Chapter 8 – Consultation Process

407 TRANSITWAY – WEST OF HURONTARIO STREET TO EAST OF HIGHWAY 400

MINISTRY OF TRANSPORTATION - CENTRAL REGION

| DRAFT ENVIRONMENTAL PROJECT REPORT COMMENT AND RESPONSE LOG | | | | | | |

TABLE 8.2: 407 TRANSITWAY – WEST OF HURONTARIO STREET TO EAST OF HIGHWAY 400

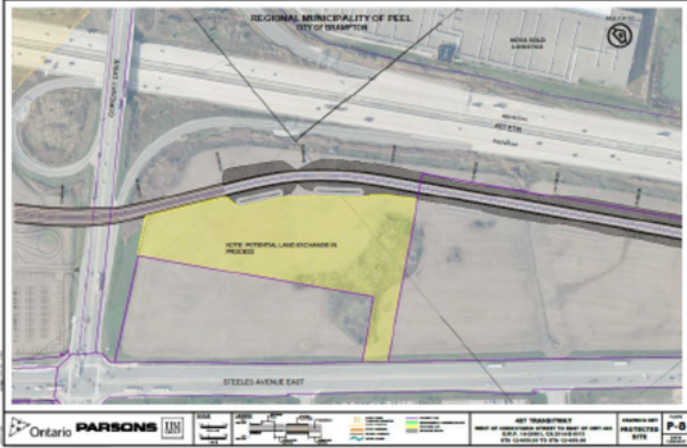
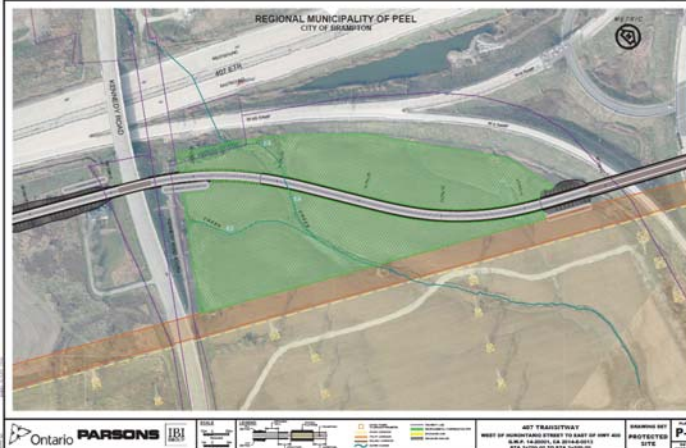
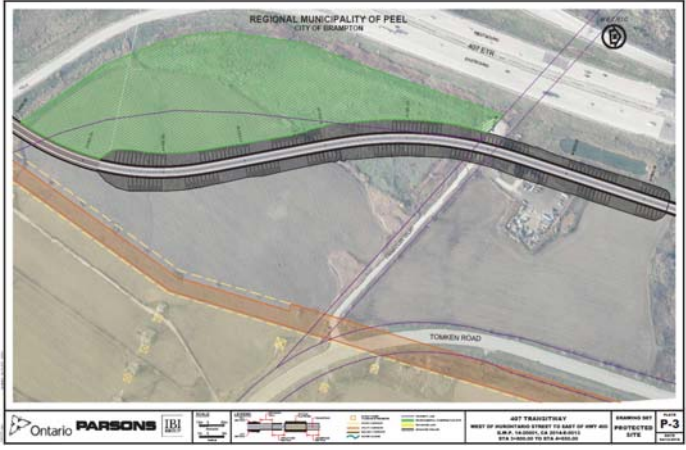
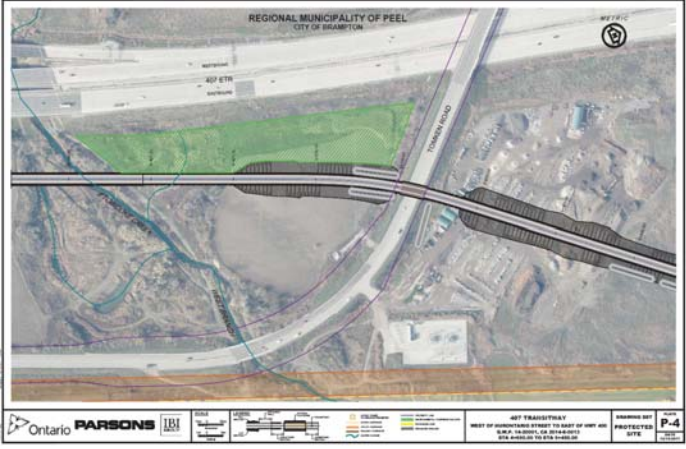
| DRAFT ENVIRONMENTAL PROJECT REPORT COMMENT AND RESPONSE LOG | | | | | | |
|---|--------|---------------|-------------|---|--|-----------------------------|
| | | | |  <p>3. MOI Lands East of Martin Grove Road</p> <p>The site east of Martin Grove Road (shown on Plate P-10 of the draft EPR, Figure 3 below) is approximately 9 acres, has frontage on Martin Grove and exposure to Highway 407. It has a flat topography and most of the site appears to be unconstrained by natural heritage features (and has historically been farmed). There may be potential to remove this parcel from the Parkway Belt and redesignate it locally to permit industrial or commercial uses, once the Transitway EA is approved and it has been confirmed it is not required for a future interchange. IO requests MTO remove it from the list of sites protected for compensation.</p> <p>The transitway runningway is shown as being at grade east of Martin Grove Rd. at the location of the potential future Martin Grove Rd./Kipling Ave. interchange with Highway 407. If the interchange goes ahead, will it be above or below grade to accommodate the proposed transitway runningway? It is not clear how the potential future interchange will affect the transitway. IO requests additional details on the relationship between the potential future interchange and the transitway at this location.</p> <p><i>Figure 3: MOI lands east of Martin Grove Road, south of Highway 407, Vaughan</i></p> |    | |
